## GR/GU ABS valve bracket installed incorrectly

**UCHP SCC CODE:** S7455

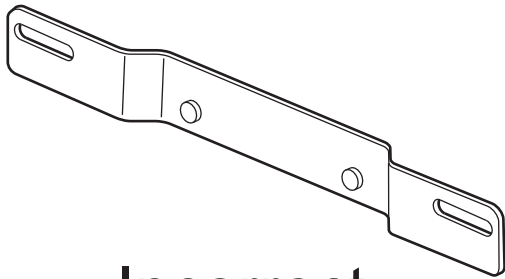
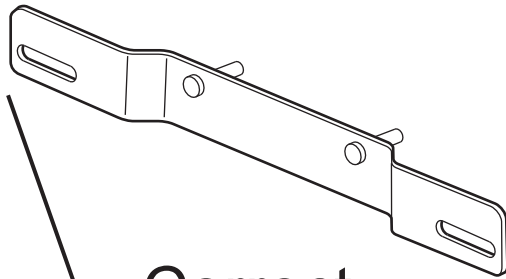
136 GR/GU trucks were built with an ABS valve bracket installed incorrectly, p/n 22681742.

This bracket was installed upside down, allowing the attached valves to in some cases make contact with the lower radiator hose.

Incorrect

Correct

To correct this condition, the bracket needs to be removed and reinstalled in the correct orientation. (see attached photo/diagram)
